# SUBSURFACE WASTEWATER DISPOSAL SYSTEM APPLICATION

Town, City, Plantation: **PORTLAND PEAKS ISLAND WOODS ROAD** Street, Road, Subdivision: **92-6-31** Owners Name: **STEVEN McISAAC**

Re: MacIsaac Property, Peak's Island

TO: Mr. Joseph E. Gray, Jr., Director of Planning and Urban Development  
FROM: P. Samuel Hoffses, Chief of Inspection Services ~~PH~~ March 14, 1990  
SUBJECT: Mr. Steven MacIsaac Property 92-G-31 Wood Road, Peaks Island  
Building Permit Revocation

**WATER DISPOSAL PLAN**

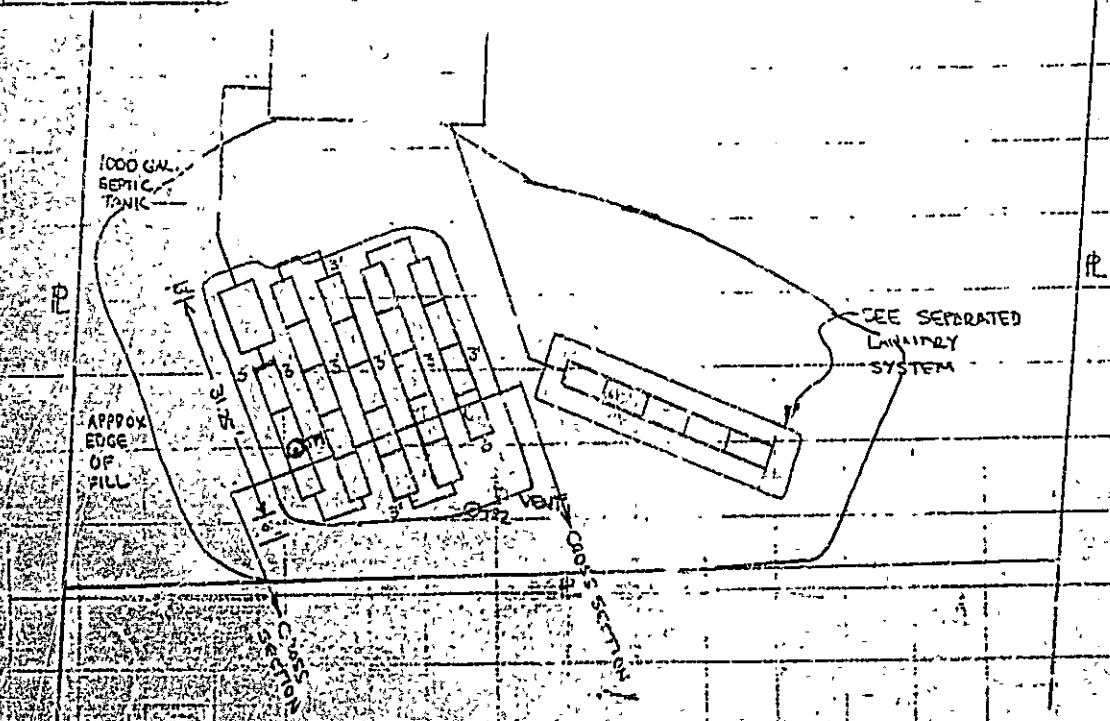
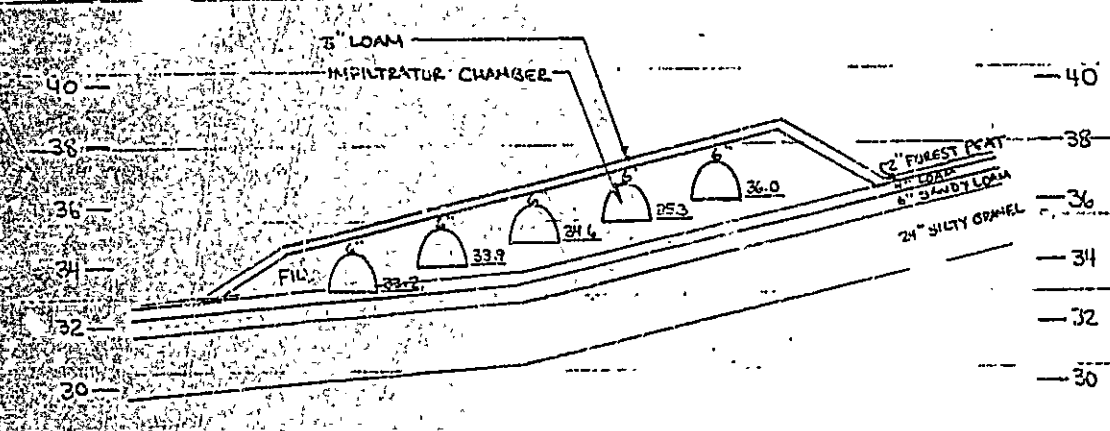
I have reviewed the revised "Subsurface Wastewater Disposal System Application" as prepared by William B. Goodwin and submitted by Steven MacIsaac on April 20, 1990. I note that the soil evaluations are based upon the same two test pits as the previous submission of May 1989. Those evaluations having been conducted by William Goodwin on March 27, 1989. It is my understanding, as a result of inquiries made of your office by my attorneys, that a revised "Topographic Site Plan" could not be located and it was uncertain whether one had been submitted with this Application as required.

I trust you recall the November 6, 1989 site review attended by Jay Hardcastle, William Goodwin, yourself and other City staff. I am also certain that you will recall one of the blatant site plan discrepancies, and one of several which invalidated the sewage system Permit of last June; was the actual location of a rock outcrop within the westernmost row of proposed infiltration chambers.

I overlaid the sewage system plan dated 2 May 89 with the revised system plan dated 28 Nov 89 to note the design changes; both being on page 3 of 3 of the Application forms as prepared by William Goodwin. I discovered several curious things. The system plans are virtually identical; the property lines, house location, laundry system, and lettering on both plans match perfectly. Two things are not identical. The first is the number of infiltration chambers for the wastewater system in each of the five rows of such chambers; the septic tank was relocated away from the house and into the westernmost row to overcome the inadequate setback from a man-made ditch of the May 1989 submission. However, the location of the five rows of chambers is identical between the two plans, and the westernmost row of chambers on the April 1990 submission is in exactly the same location as the westernmost row of the May 1989 submission. This means the westernmost row in the revised system plan, dated 28 Nov 89, still straddles the rock outcrop observed in the field earlier that month. The second curious thing is the test pit locations are not the same in both plans. The test pit TP1 has been illustrated within the westernmost row of chambers of the 28 Nov 89 plan. I believe this creates the impression that the sewage disposal field has been moved easterly off the rocks. The location of test pit TP2 matches perfectly between the 1989 and 1990 submissions. However, the space between TP1 and TP2 has apparently and inexplicably increased from 20 feet on the plan prepared by Goodwin dated 2 May 89 to 27 feet on the plan prepared by Goodwin dated 28 Nov 89. The Topographic Site Plan, signed and stamped by Registered Land Surveyor Gary E. Johnson, which accompanied the May 1989 Application indicates the two test pits have a spacing of 20 feet. I am greatly concerned this

I trust you will agree that the City has given every reasonable opportunity to MacIsaac to revise and correct the Subsurface Wastewater Disposal System Application. Now it is time to revoke the Permits. If a new application is made for a subsurface wastewater disposal system at this site, I trust the complete site information required in Section 6 of the Subsurface Wastewater Disposal Rules will be provided, that the system limits will be marked in the field as required to assist review by City/State officials, and that a thorough site evaluation and design compliance review will be conducted before the permit is granted.
